To: Susan Becker, TUV Product Service Inc
From: Linda Elliott
lelliott@fcc.gov
FCC Application Processing Branch

Re: FCC ID OLZR4170
Applicant: New Japan Radio Co. Ltd.
Correspondence Reference Number: 8922
731 Confirmation Number: EA94843
Date of Original E-Mail: 07/27/1999

The Position of FCC ID Number

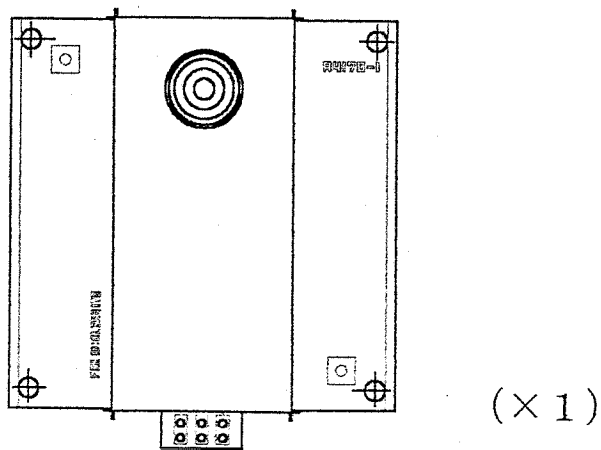
The FCC ID is not shown on the drawing of the identification label. Submit a revised identification label, via your electronic application EA94843, as appropriate. Also, indicate where the compliance statement will be placed on the device, pursuant to Section 15.19(a)(3) of the Rules. If the device is too small to be placed on the device, then it must be shown in the users manual. See Section 2.1033(b)(3) of the Rules.

The following statement will be placed on the container in which the device is marketed:

This device complies with part 15 of the FCC rules.
Operating is subject to the following two conditions:
(1) This device may not cause harmful interference, and
(2) this device must accept any interference received including interference that may cause undesired operation.
